Detailed Site Plan South Lake Commercial - Phase 1

DSP-19021-02

REQUEST	STAFF RECOMMENDATION
Amendment to the approved detailed site plan for additional signage, revised architecture including a reduction in gross floor area, and additional site details.	With the conditions recommended herein: APPROVAL of Detailed Site Plan DSP-19021-02

STAFF REPORT

REVISED ARCHITECTURE – PAD SITE 21

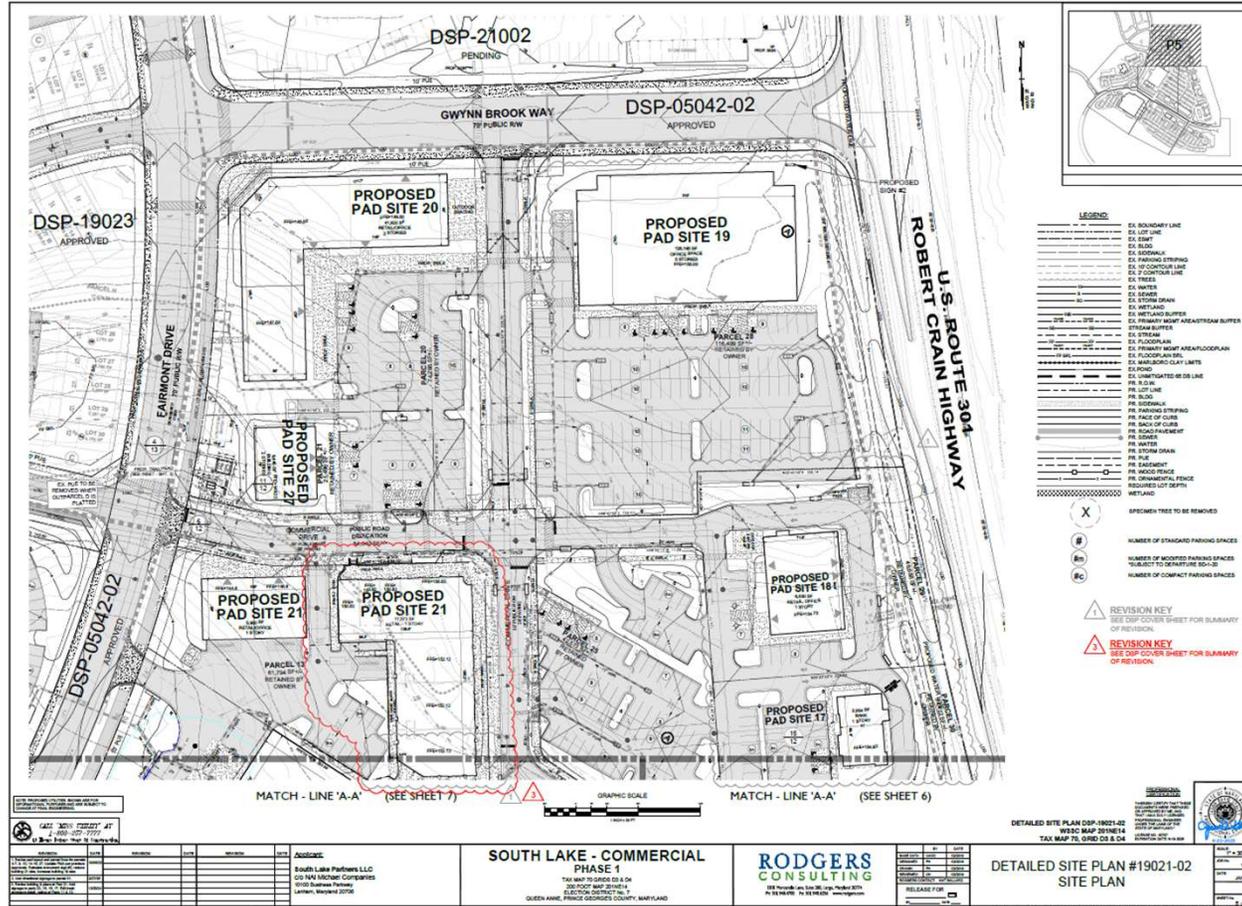
The application requests a revision to the architecture for Pad Site 21 on Parcel 13. The proposed architecture removes a formerly envisioned second-floor office component, reducing the total GFA included in this DSP to 841,296 square feet. The revised architecture incorporates a mix of colors, materials, and textures, including masonry, metal coping, storefront windows, and metal panels. The design of the building is modern, with variations in roof height creating architectural interest. Special attention has been paid to the façades that face public spaces to feature façade articulation, varied roofscapes, and customized shopfronts along Commercial Drive, and an attractive view from the adjacent plaza.

The revised building architecture for Pad Site 21 includes a variety of materials, façade articulation, varied roofscapes, and customized shopfronts, as discussed in Finding 6 above.

The revised building architecture for Pad Site 21 promotes attractiveness from public spaces, as discussed in Finding 6 above.

PROPOSED REVISED GATEWAY SIGN

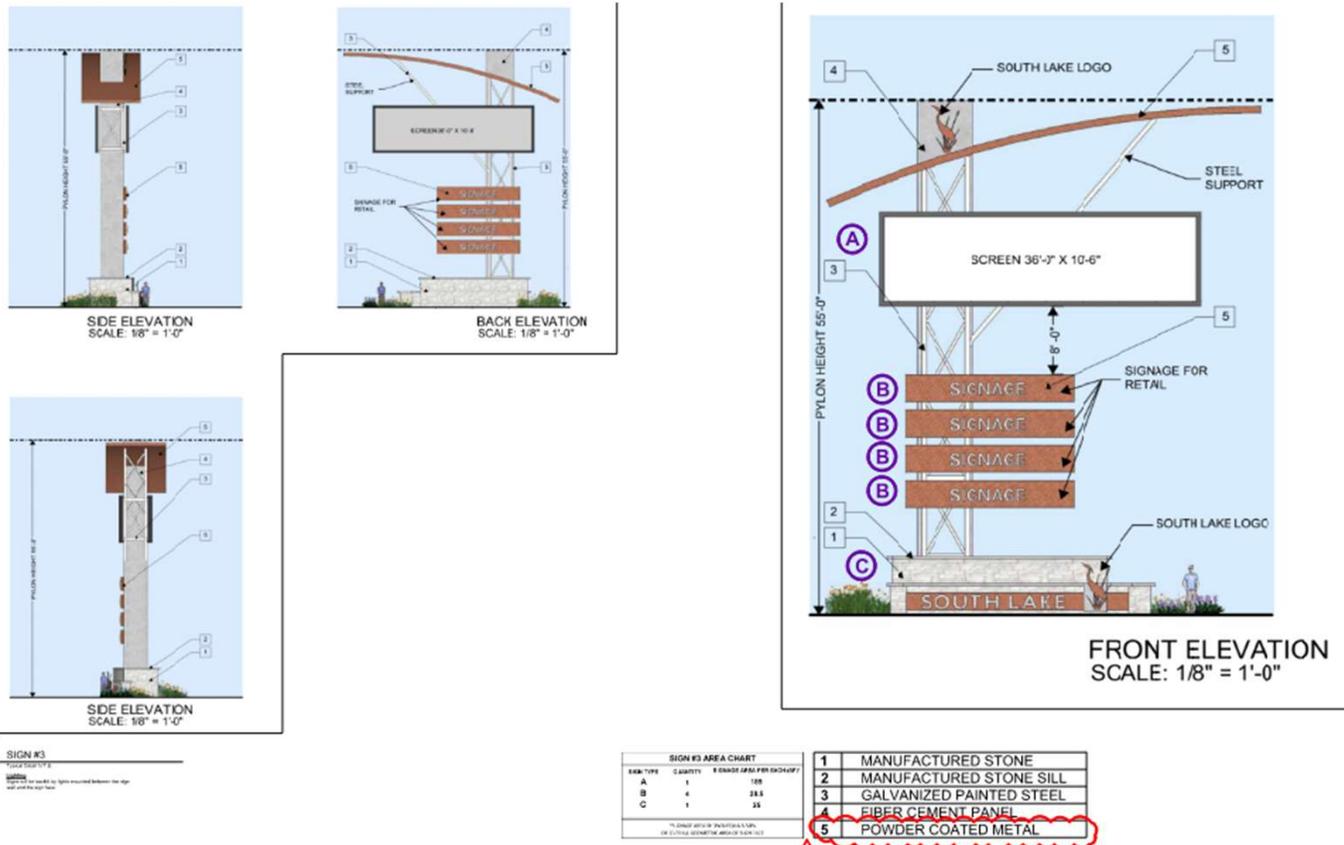
The revised multi-tenant gateway sign is highly similar to the previous approval, however, one material which is featured on the signage for retail and the South Lake logo has been changed from high-density wood to powder coated metal.

PROPOSED NEW SITE DETAILS – BENCH PLANTER

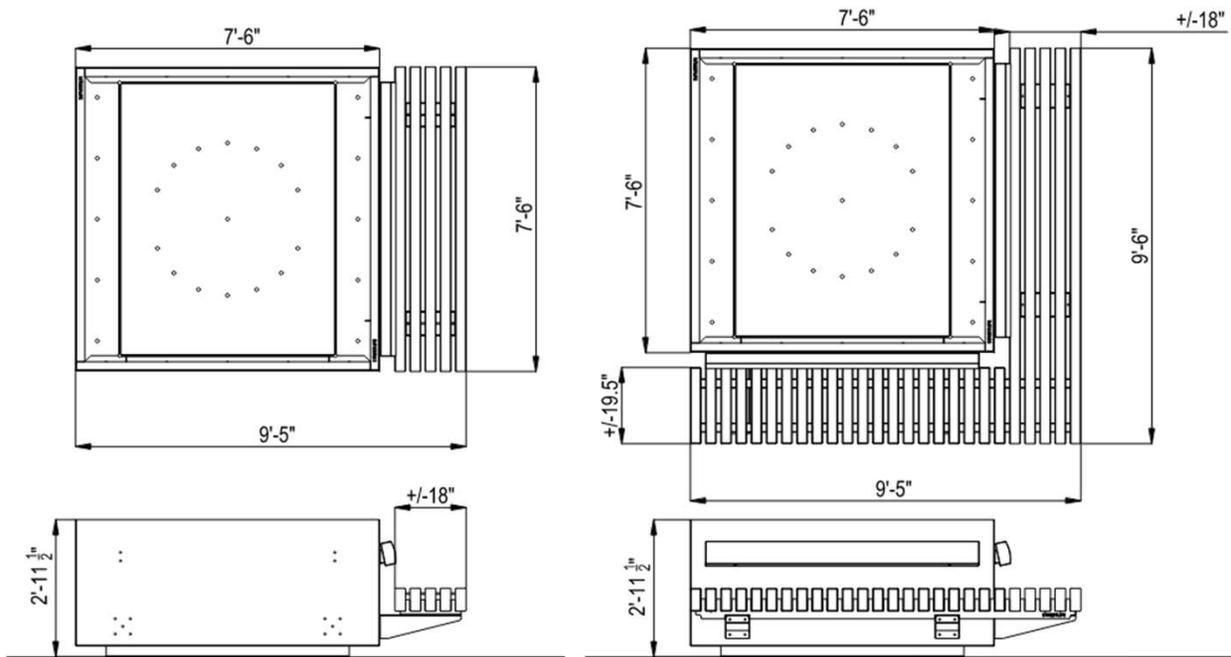
Additional site details are included in this DSP. Specifically, a new plaza bench and planter is proposed, along with additional trash enclosure details.

As a whole, the South Lake development, inclusive of the subject DSP, provides amenities including plazas and park spaces, and recreational opportunities including the Collington Branch Trail. A mix of retail, restaurant, and entertainment uses is approved with DSP-19021. The subject DSP includes additional plaza amenities including a combination bench and planter, providing shaded seating in the plaza on Parcel 13.
